Reconfiguration of Car Parking, Bicycle Parking and Landscaping

River Court, 5 West Victoria
Dock Road, Dundee

Report by: Executive
Director of City Development

SUMMARY OF REPORT

Figure 1 – Proposed Site Plan

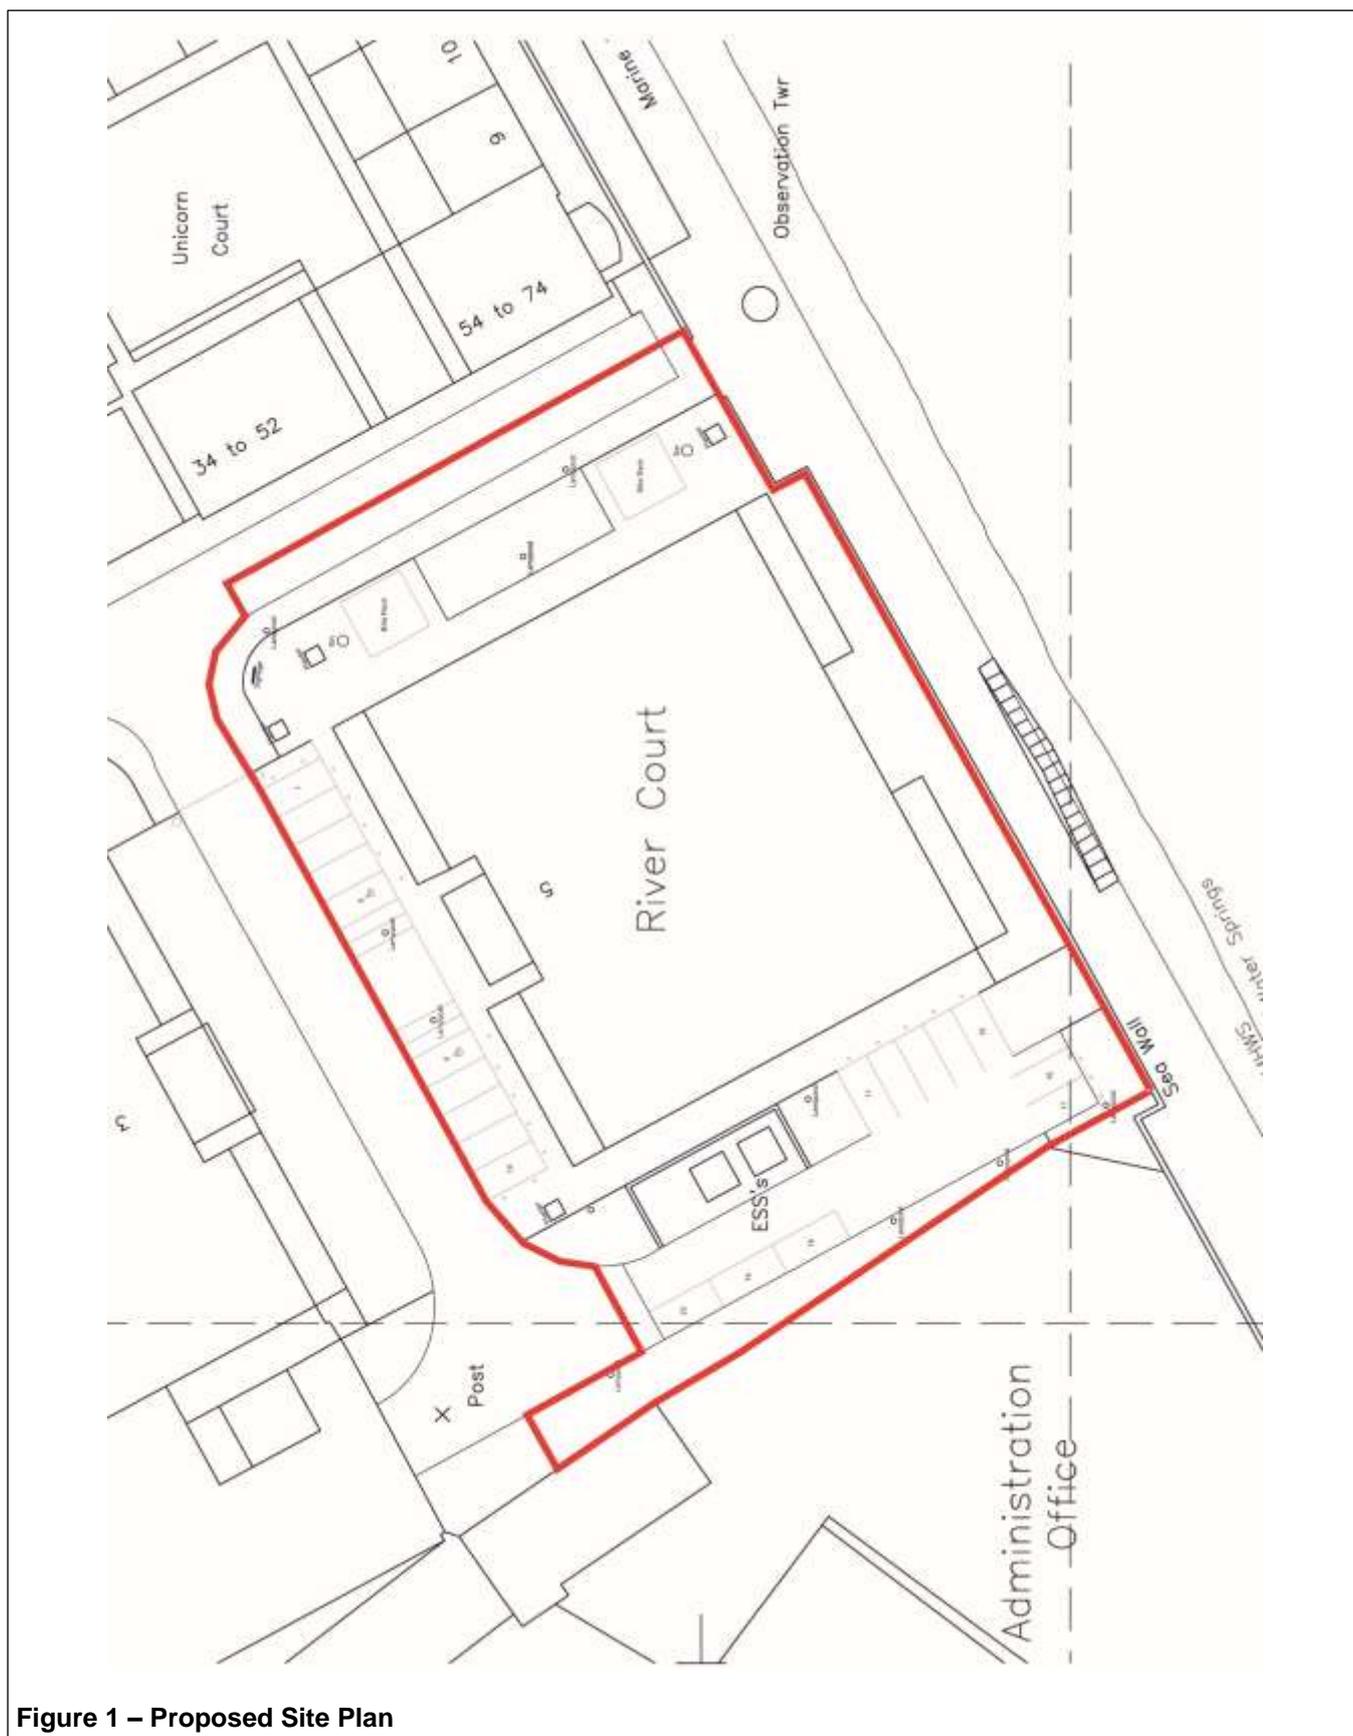
- 7.4 The proposal would result in the removal of a footway, an area of landscaping, and the cycle storage areas. These would be replaced with parking spaces for private vehicles. This would have an adverse impact on the street scape and would impact on pedestrian and cyclist safety with the removal of the footway. The proposal would adversely impact on accessibility to the Green Circular and National Cycle Network 1 which is routed down West Victoria Dock Road. Additionally, should this application be approved, it would likely set a precedent for the loss of other attractive safety and convenience features at other nearby office sites, particularly that to the north at Rushton Court, to the overall detriment of the area. The proposal is therefore not of high quality design and would be contrary to Policy 7.

- 7.7 In this case, it is proposed to remove trees and shrubs to allow the development of the parking spaces, and remove a flower bed to install bicycle storage. The number of trees to be felled has not been specified. The proposals are not accompanied by plans for any replacement tree planting. Compensatory planting is proposed as raised flower beds to border the new car parking spaces, which is not considered to be satisfactory replacement planting for the loss of trees. The proposals are therefore contrary to the terms of Policy 38.

- 7.21 As detailed above, there is no acceptable justification for the increase in car parking spaces. The original Travel Plan dated 2008 has not been updated. The submitted plans illustrate that an existing footway would be removed by the proposed car parking spaces and a street lighting column would be affected and the proposed layout is therefore unacceptable. Provision of electric car parking bays is required within the car parking area and must be provided above the level of car parking to meet Dundee City Council transport standards. This has not been proposed as part of the planning application. It is therefore considered that the proposal would affect the existing road network in terms of safety, in removing a pedestrian footway and potentially compromising a recognised national cycle route. There is no promotion of alternative transport methods.
